PRELIMINARY PLAT APPLICATION

File # S1B23-001

ISSUE STATEMENT: PUBLIC HEARING AND RECOMMENDATION TO NIXA CITY

NORTH OWEN ROAD KNOWN AS CENTURY HEIGHTS

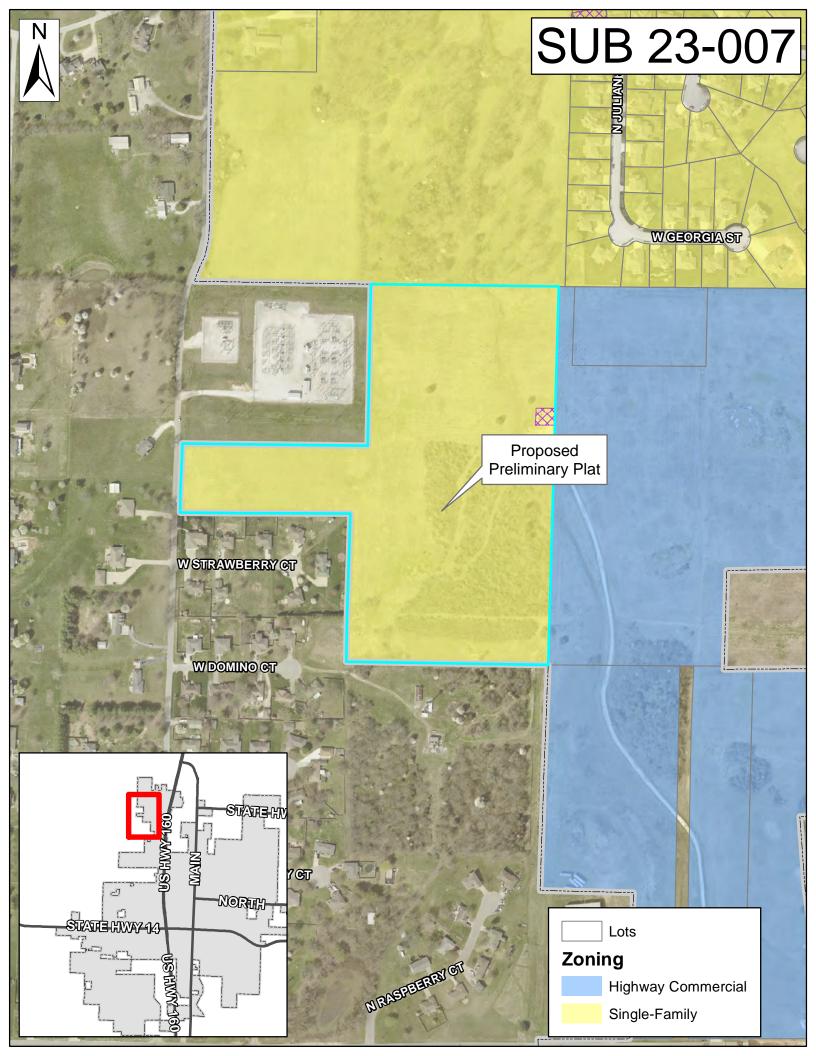
A Geotechnical Investigation was performed in February of 2022. This investigation identified five potential sinkholes in the area, three on the subject property. This report does not meet our current standards for a sinkhole evaluation. The City will require that

a new sinkhole evaluation be performed by a registered Geologist in the State of Missouri, to City standards, before construction plans can be reviewed.

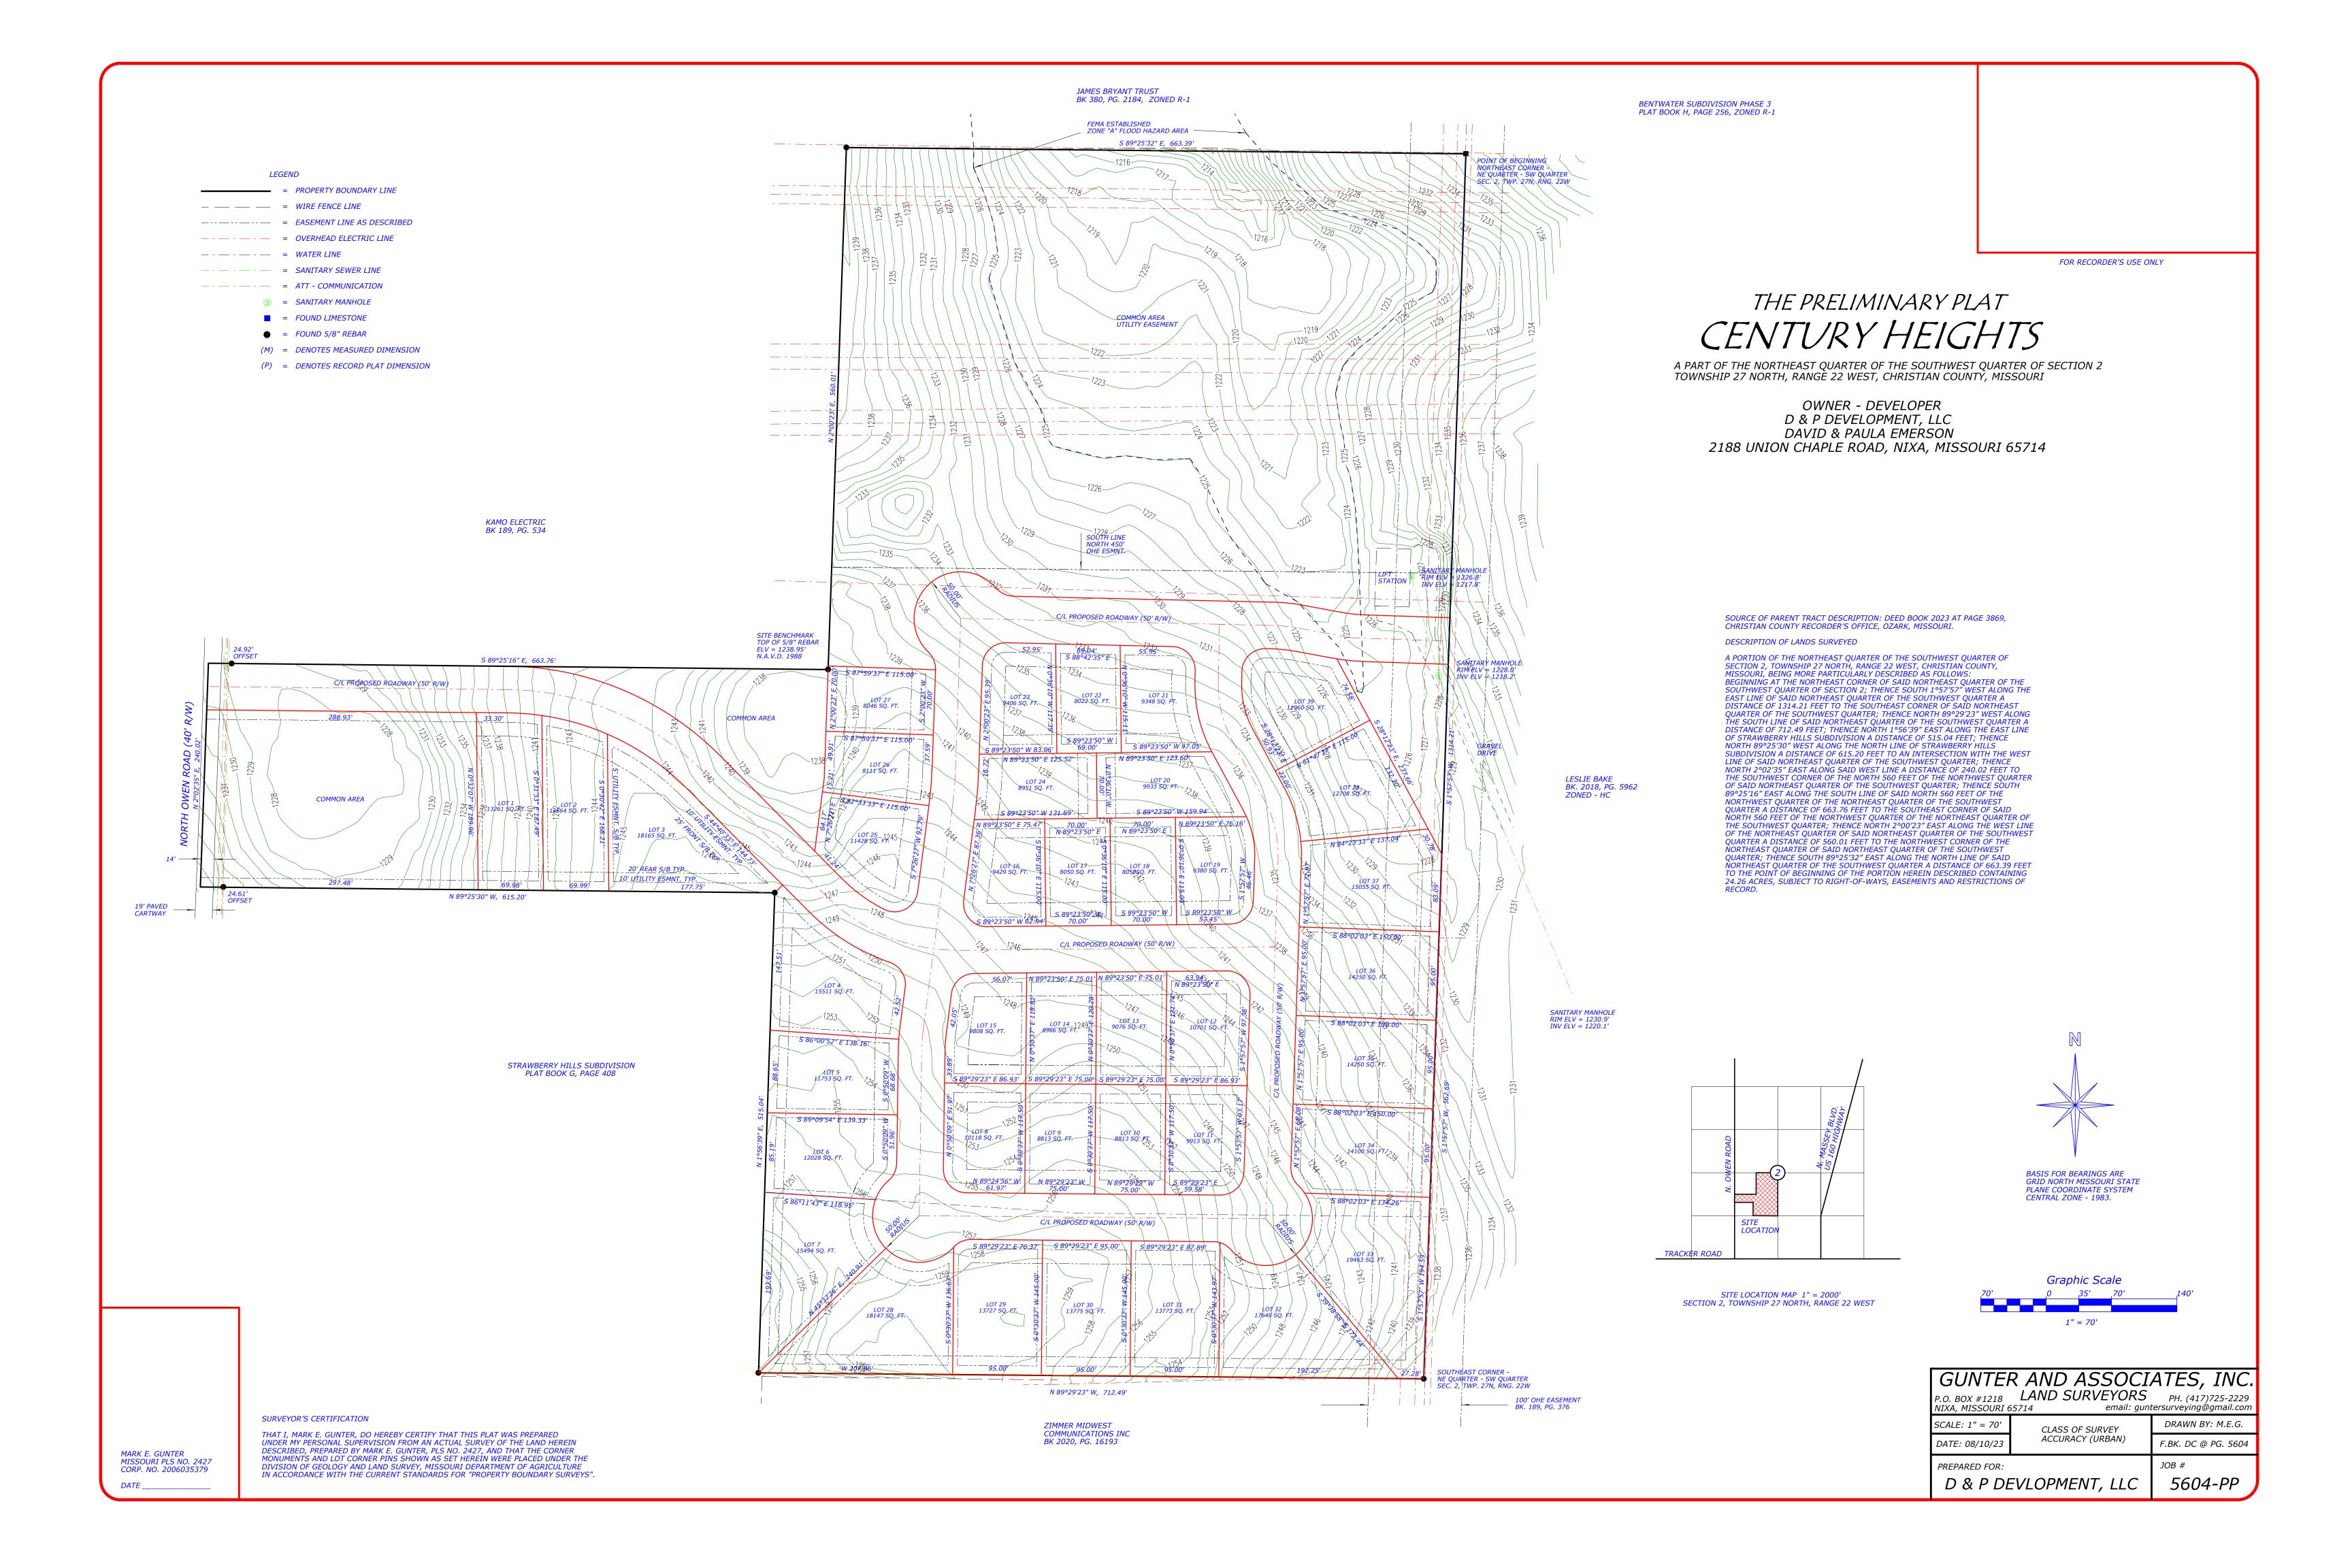
The proposed subdivision consists of two stormwater drainage areas. The west drainage area consists of three buildable lots and drains to the sinkhole found by Owen Road. The rest of the proposed subdivision drains to the north to a sinkhole. Development will conform to City standards for stormwater runoff into sinkholes.
